# 適航指令發布單 Airworthiness Directive Issuance Form

民航局AD編號 AD number	CAA-2024-10-003	發布日期 Date issued	2024/10/14												
適用之航空產品 Applied to (models, serial numbers or part numbers, as applicable)	This AD applies to The Boeing Company Model 777-200, -200LR, -300, -300ER, and 777F series airplanes, certificated in any category, as identified in Boeing Alert Requirements Bulletin 777-53A0100 RB, dated March 16, 2023.														
主旨摘要 Subject	This AD requires external or internal (depending on configuration) inspections for any cracking of the left and right side fuselage skin common to the UWL, and applicable on-condition actions.														
民航局 CAA  <input type="radio"/> 本國產品 Native product  <input type="radio"/> 其他個案 Other	設計國民航主管機構 Original Authority

**[Docket No. FAA-2024-0769; Project Identifier AD-2023-00556-T; Amendment 39-22815; AD 2024-16-09]**

### **Airworthiness Directives; The Boeing Company Airplanes**

**Figure 1 to Paragraph (h)(3)—Cap Sealing Dimensions (all Dimensions are in Inches)**

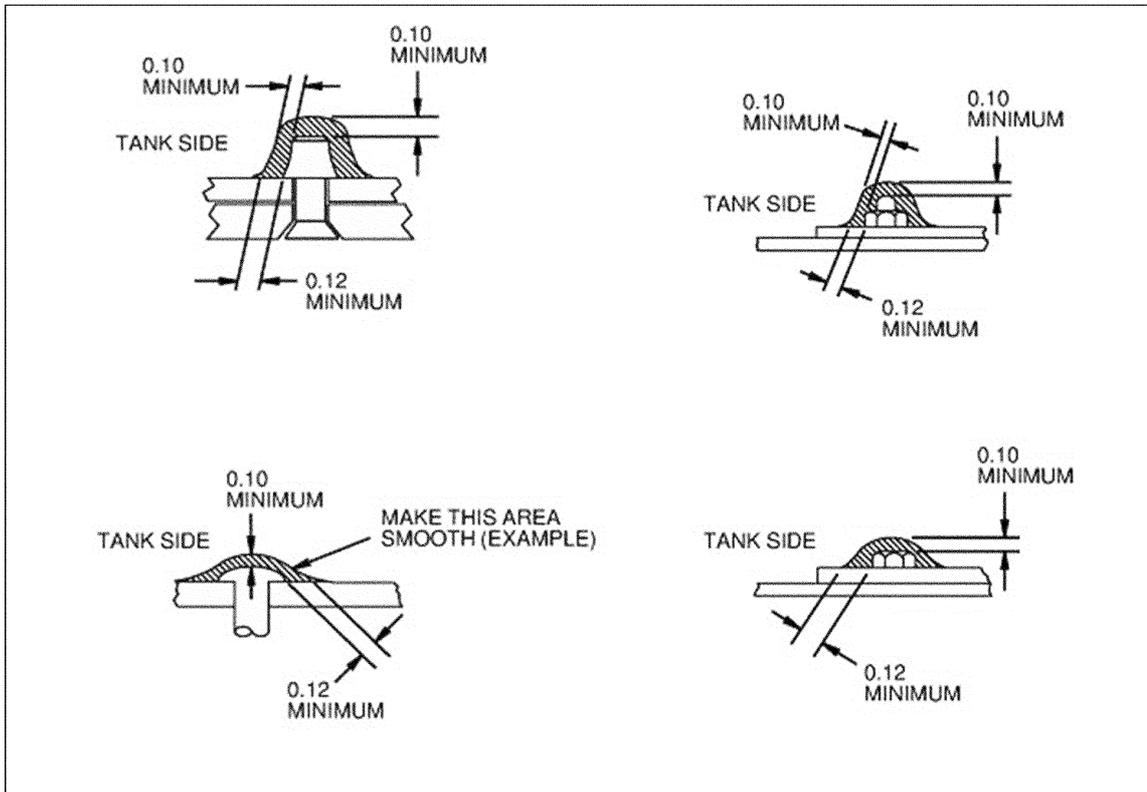
Boeing requested that paragraph (h)(3) of the proposed AD be clarified to specify that only the fuel tank side of fastener locations that penetrate the fuel tank boundary require cap seal dimensions to meet the dimensions given in Figure 1 to paragraph (h)(3) of the proposed AD. Boeing stated that the service information referenced in Boeing Alert Requirements Bulletin 777-53A0100 RB, dated

March 16, 2023, contain instructions for applying cap seals to fasteners that penetrate a fuel tank boundary and fasteners that do not penetrate a fuel tank boundary. Boeing added that for fasteners that do not penetrate a fuel tank boundary, fastener sealing is used as a pressure seal to help mitigate corrosion and have sealing specifications that include minimum thickness requirements less than the amount shown in paragraph (h)(3) of the proposed AD that are acceptable for their intended function outside of the fuel tank. Boeing stated that for fasteners that penetrate the fuel tank, the cap seals on the interior side of the fuel tank act as a primary fuel seal, providing fault tolerance against electromagnetic effects (electrical fault currents and lightning currents), and are also cap sealed on the exterior side for corrosion prevention.

Boeing concluded that only the cap seals on the interior side of the fuel tank require the dimensions specified in Figure 1 of paragraph (h)(3) of the proposed AD to perform their intended function, which is consistent with the labels shown in Figure 1 of paragraph (h)(3) of the proposed AD. Boeing recommended replacing the text “applying a cap seal (sealant) to a fastener, fastener head, and fastener threads and collars, for this AD, during application of any cap seal to a fastener, fastener head, or fastener threads and collars” with the text “applying a cap seal (sealant) to a fastener location that penetrates the fuel tank boundary, for this AD, during application of any cap seal to a fastener, fastener head, or fastener threads and collars inside the fuel tank.”

Boeing requested that the FAA add a note to paragraph (h)(3) of the proposed AD to refer to Boeing Model 777 Aircraft Maintenance Manual (AMM) section 28-11-00 as an acceptable cap sealing procedure to accomplish the actions required in that paragraph. Boeing stated it has received numerous queries from operators on Figure 1 to paragraph (h)(4) of AD 2023-17-14, which is identical to Figure 1 to paragraph (h)(3) of the proposed AD. Operators have asked whether Boeing Model 777 AMM section 28-11-00 would be an acceptable procedure for accomplishing the

requirements of paragraph (h)(4) of AD 2023-17-14. Boeing stated it believes that AMM 28-11-00 is an acceptable procedure for performing cap sealing inside the fuel tank because the AMM is the source material for the contents in Figure 1 to paragraph (h)(3) of the proposed AD and contains the same minimum seal thickness dimensions as shown in Figure 1.

The FAA agrees to clarify paragraph (h)(3) of this AD for the reasons provided by the commenter. Locations that do not penetrate the fuel tank boundary do not require the same sealant application procedures. The FAA has added the text “inside the fuel tank” to paragraph (h)(3) of this AD. However, the FAA did not replace the text “to a fastener, fastener head, and fastener threads and collars” with the text “to a fastener location that penetrates the fuel tank boundary,” as recommended by the commenter, because the text “to a fastener, fastener head, and fastener threads and collars inside the fuel tank” better aligns with the language within the service information.

The FAA agrees. Boeing 777 AMM 28-11-00 meets the sealant requirements of Figure 1 to paragraph (h)(3) of this AD. As such, it would be an acceptable procedure to follow when sealing inside the fuel tank in accordance with paragraph (h)(3) of this AD. The FAA has added a note to paragraph (h)(3) of this AD accordingly.

(3) Where any service information referenced in Boeing Alert Requirements Bulletin 777-53A0100 RB, dated March 16, 2023, specifies applying a cap seal (sealant) to a fastener, fastener head, and fastener threads and collars inside the fuel tank, for this AD, during application of any cap seal to a fastener, fastener head, or fastener threads and collars inside the fuel tank, the cap seal must be

applied using a cap sealing procedure with thickness greater than or equal to the dimensions given in Figure 1 to paragraph (h)(3) of this AD.
